ADDENDUM NO. 4

PROJECT: Garvin Building Hazardous Material Abatement & Renovation Floors 3, 4, & 5

ADDENDUM #01

Building 75 – Garvin Building Hazardous Material Abatement & Renovation Floors 3, 4, & 5
425 Robinson Street
Binghamton, NY 14224

1 Fire Protection Demo Plan - 05 - WING C
FD105C 1/8" = 1'-0"

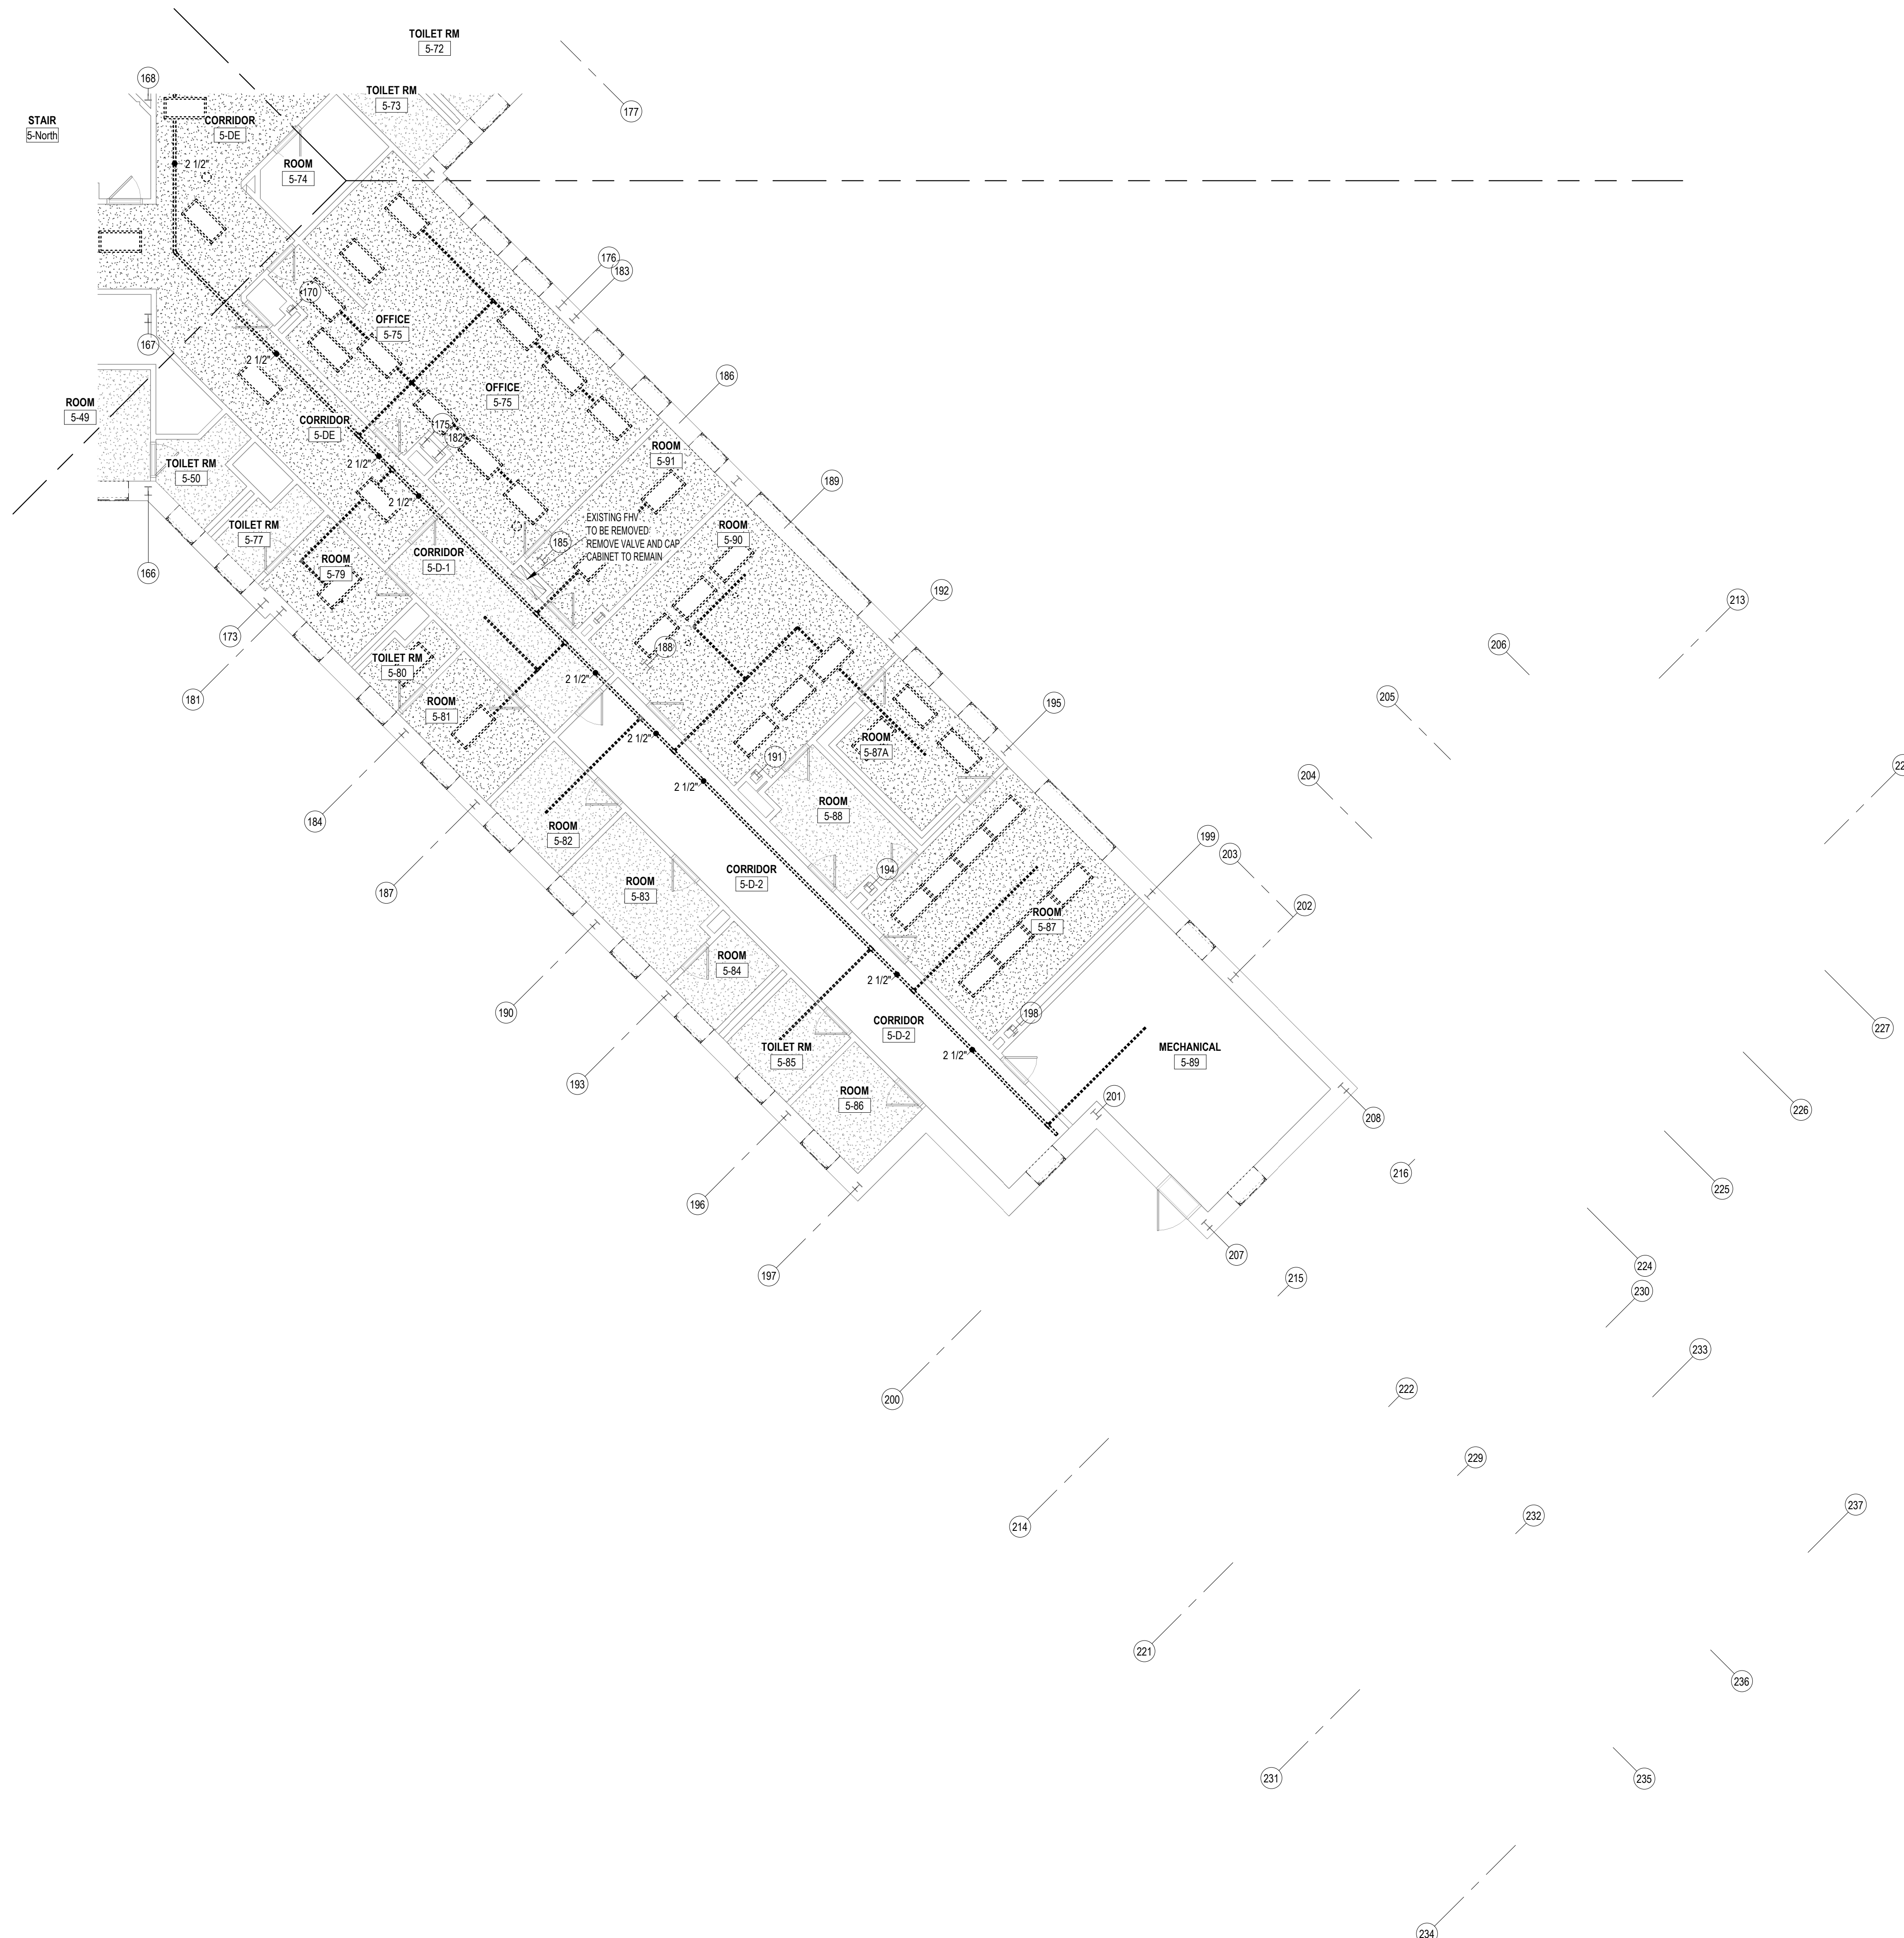
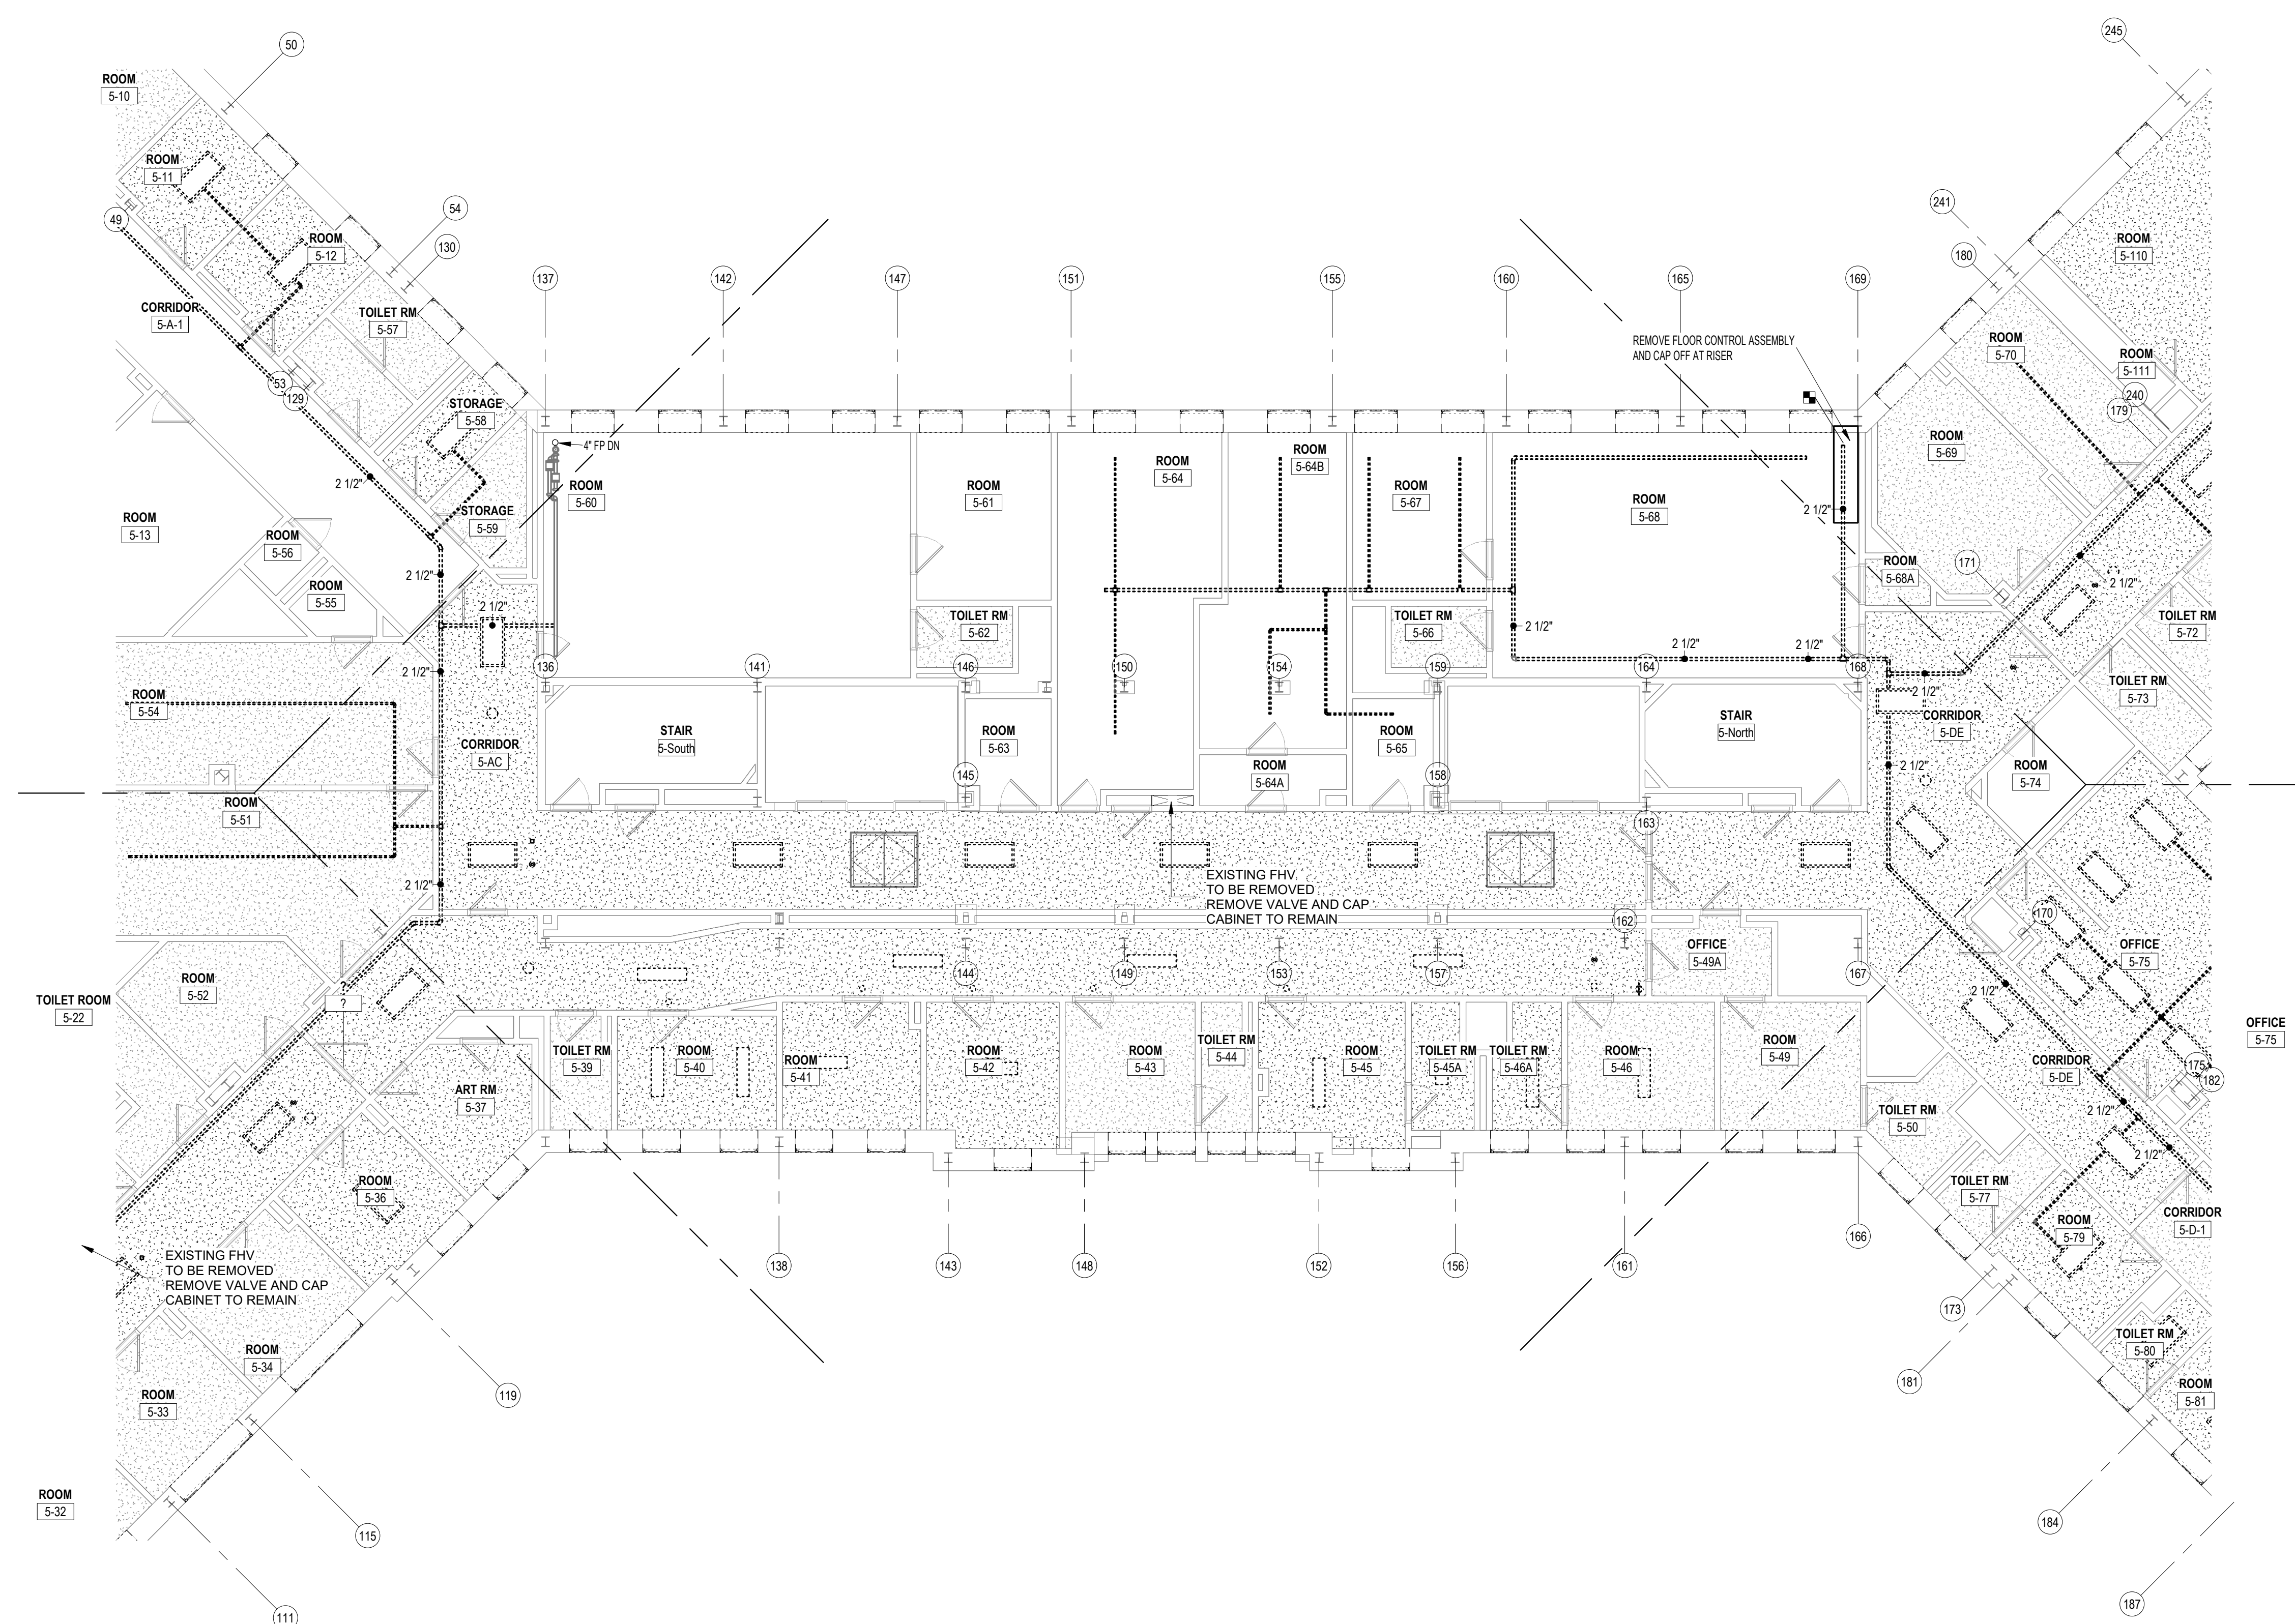
12	A501 - Window Details	Architectural	Add corridor section showing minimum clearances between soffits and new suspended ceilings.	This is to be coordinated in the field, detail will not be provided.
13	FD103A - FD105E - Partial Plan FP - Demolition Plan Wing A - E	Fire Protection	Add legends and clarify meaning of shaded rooms in demo plans	Legends has been added to the cover sheet. The shaded rooms are rooms with an existing gyp ceiling.
14	FD103A - FD105E - Partial Plan FP - Demolition Plan Wing A - E	Fire Protection	Fire protection demo plans indicate removal of all existing fire protection piping. Is selective reuse of fire protection mains an option?	Selective reuse of the existing mains may be acceptable if the condition of the pipe is acceptable. The diameter of the mains will also need to be capable to hydraulically supplying the system.
15	FD103A - FD105E - Partial Plan FP - Demolition Plan Wing A - E	Fire Protection	Are any precautionary measures required for core drilling of slabs for new risers (ex: rebar location)?	A pilot hole should be made to confirm that existing structure will not hinder the core hole for the standpipe.
